APPROVED MINUTES OF THE MEETING

September 3, 2009

September 3, 2009 Project: Madison Valley Stormwater Improvements – Phase II

Phase: Schematic Design
Last Reviewed: March 19, 2009; June 4, 2009
Presenters: Celia Kennedy, SPU
Gail Staeger, Nakano Associates
Tom Finnegan, MWH

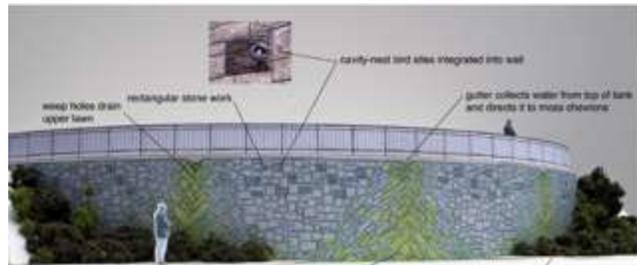
The Commission approves the 60% Design Development Review with a vote of seven to one. The dissenting vote was on the grounds that the various geometries of the design specifically the paving pattern on the lid of the tank, the access hatches and the rhythm of the railing are not integrated and working well together. The Commission has the following recommendations:

- The Commission strongly encourages close collaboration among the artist, engineers, and landscape architect in resolving details and the design to work out the details to make all the elements feel considered. All drawings from now on should show the artwork on the wall.

- The Commission is excited that the artwork was integrated early into the other aspects of the design so that it helps express the story of the stormwater. However, the team including the artist should be careful to address the appropriate level of physical access to the art.

- The team is encouraged to review the legibility of how and where water flows to the wall, how it is expressed and how it relates to the wall. Close attention should be paid to the edge where the tank lid and the wall come together.

- The team is also asked to coordinate how the handrail along the edge of the lid and the other vertical and horizontal elements meet.
- The team is asked to resolve the conflicting radial geometry of the access hatches and the linear paving pattern.

- The Commission strongly supports providing seating on the top of the tank.
- Commissioners ask that the drainage issues around the truck turn around be examined and solved, perhaps by adding a berm and draining to the north side rather than across/under the path at the truck turn-around.

- **The Commission also cautions using crushed rock on the pathway with slopes of 14% or more. Appropriate research should be done to ensure the path will be secure and that installation will not conflict with the goal of preserving the native woodland trees.**
- **The Commission commends the use of native plant species and encourages the team to consider planting mixed aged/height trees to create a greater illusion of older woodland. The team also encourages the inclusion of a few madronas.**
